**ANGEL PLACE
LEVEL 8, 123 PITT STREET
SYDNEY NSW 2000**

SSD MODIFICATION MOD 4 OF SSD 6454 - 272 MILITARY ROAD, CREMORNE REDLANDS SENIOR CAMPUS CONCEPT PROPOSAL & STAGE 1 WORKS

Figure 1 - Elevations

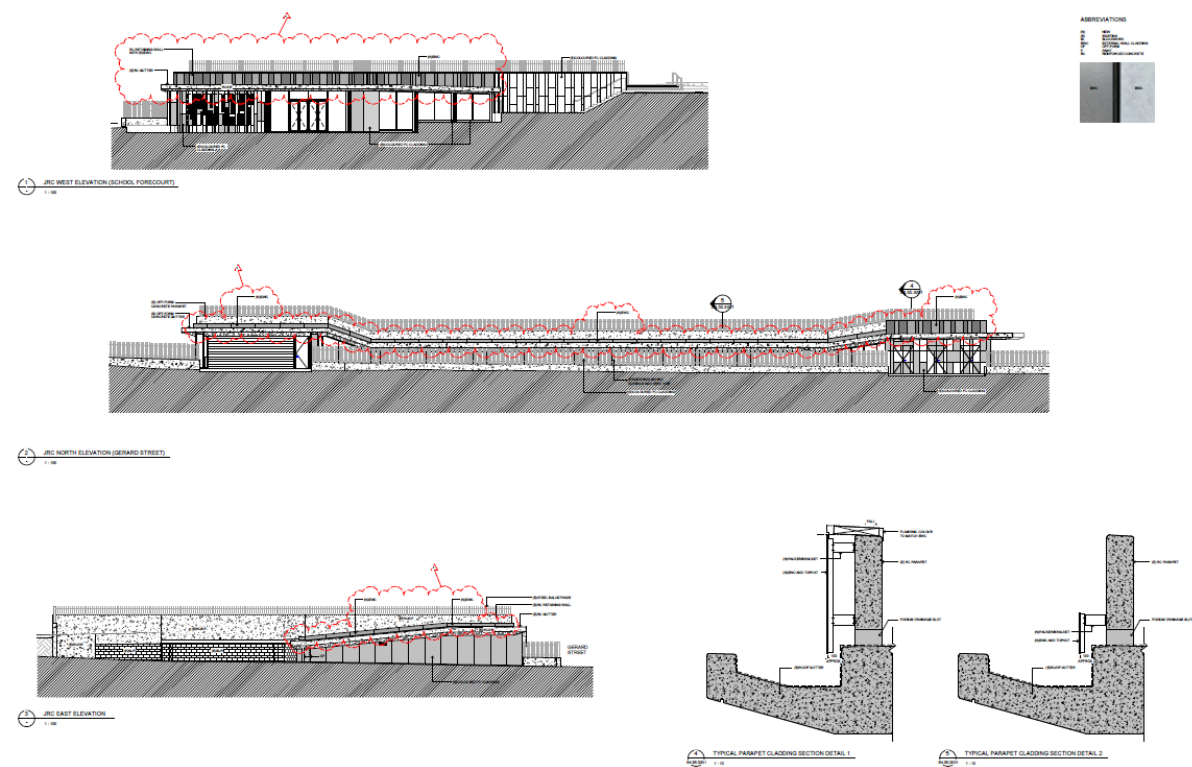
The proposed modification to SSD 6454 is for the addition of fibre cement cladding to the external façade of the parapet on the north, west and east elevations of the John Roberts Centre (Interim Music Hub). The reason for the modification is that the current concrete cladding is of low construction quality and does not meet the required standard for the finish. This has resulted in poor presentation to the street and at the entrance to the school campus. The modified drawings are attached at Appendix A and shown in Figure 1 on the following page. A comparison of the approved and proposed Stage 1 development is shown in Figures 2 and 3.
